## 2 Type of change

## 3 Detailed description of change

USF 1206					0118.2205	
creation date	created by	release date	released by	notification no.	revision	page
2014-01-29	ganderka	2015-01-30	ruettiha	26101	a	1 of 2

Current marking and layout (example)	New marking and layout (example)

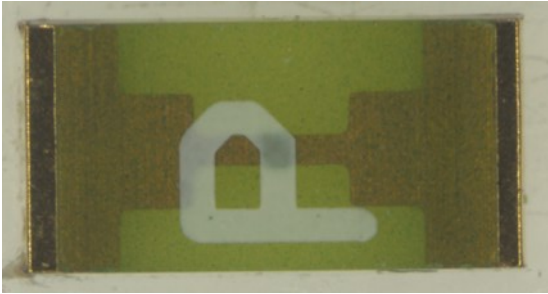
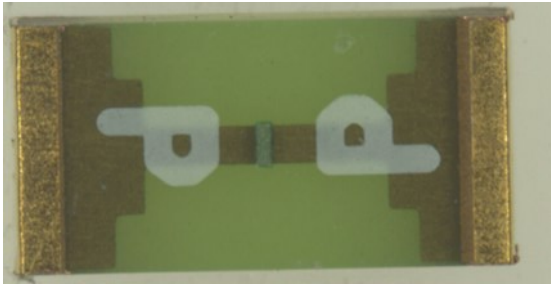
Letters do not change

- Symmetric marking to provide marking readability independent from device placement in blister
- Layout of conductive path adapted to minimise voltage drop in order to enhance the performance
